## **URGENT: MEDICAL DEVICE CORRECTION**

### **Software Distribution Network & Associated Programmers**

<b>Product Name</b>	<b>Model Number</b>
CareLink™ 2090 Programmer	2090; All Serial Numbers
CareLink Encore™ 29901 Programmer	29901; All Serial Numbers

10 October 2018

## Appendix A: Programmer Software Screen

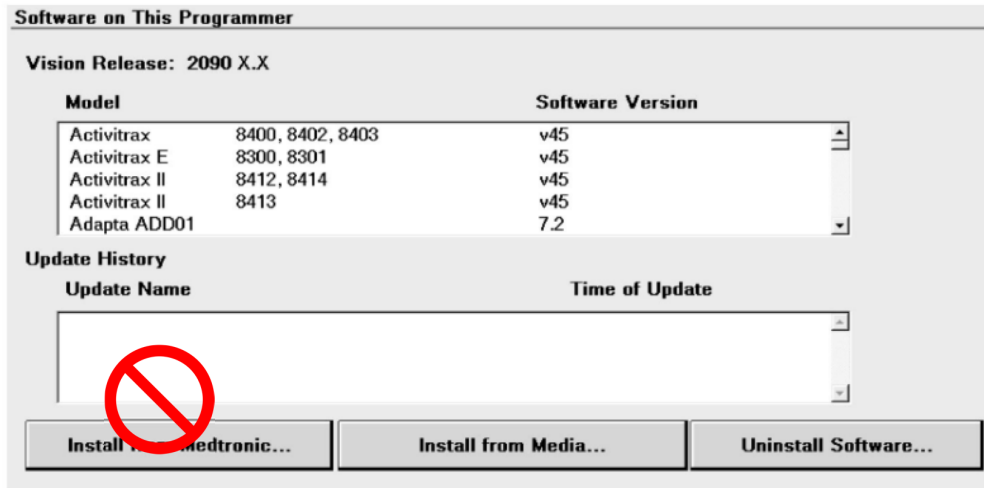
**Do not attempt to update the programmer via the SDN.** If you select the "Install from Medtronic" button, it will result in an unsuccessful installation of software because access to the external SDN is no longer available.

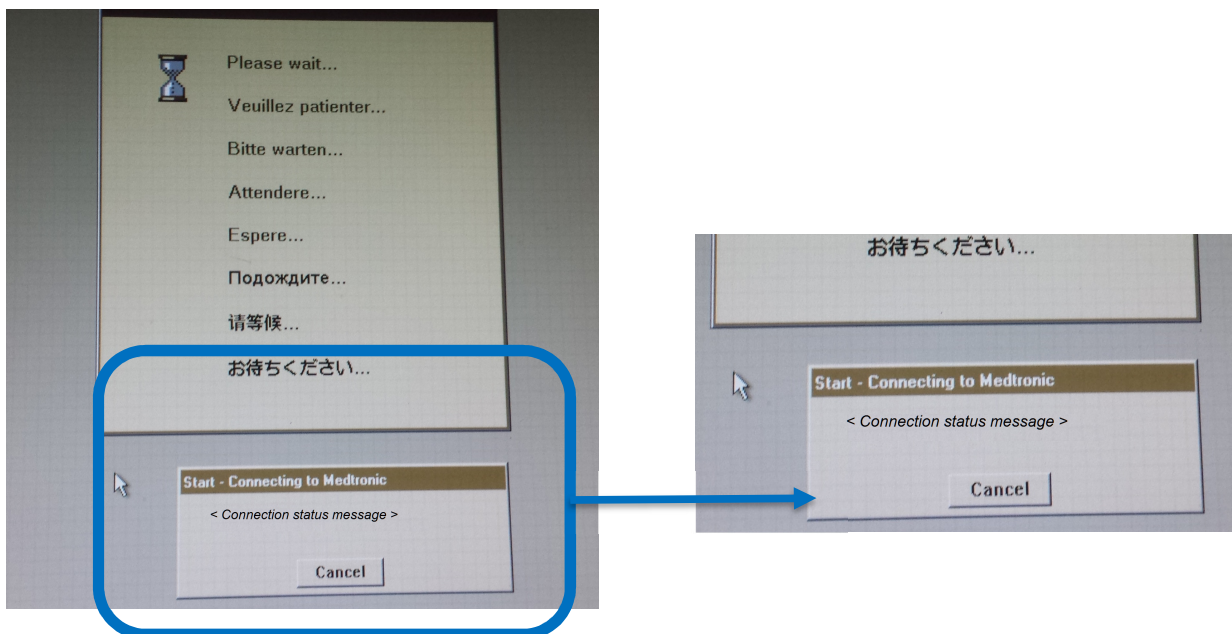
Several messages may be observed if installation of software from the SDN is attempted (e.g. "Install from Medtronic..."). See images below for example as to what will appear on the programmer display during the installation attempt. Below the larger "Please Wait" message will be a smaller window with a <connection status message> displayed; refer to highlighted area below. The connection status messages may alternate *between* "Connecting...", "Searching for Network...", "Logging in...", "Unable to connect to local network", and "Unable to connect to Medtronic". Since the SDN is no longer available, **the user should select "Cancel" to terminate the installation attempt.**

If the user cycles power on the programmer without first cancelling the installation attempt, upon power-up a count-down window will appear on the screen for approximately 30 seconds with "Yes" and "No" buttons. The user should select "No" to terminate the installation attempt and return to the Model Select screen. If the user selects "Yes" or does not respond prior to the 30-second time out, the programmer will attempt the installation again, and the process described above will repeat until the user either selects "Cancel" or selects "No" during the count-down window.
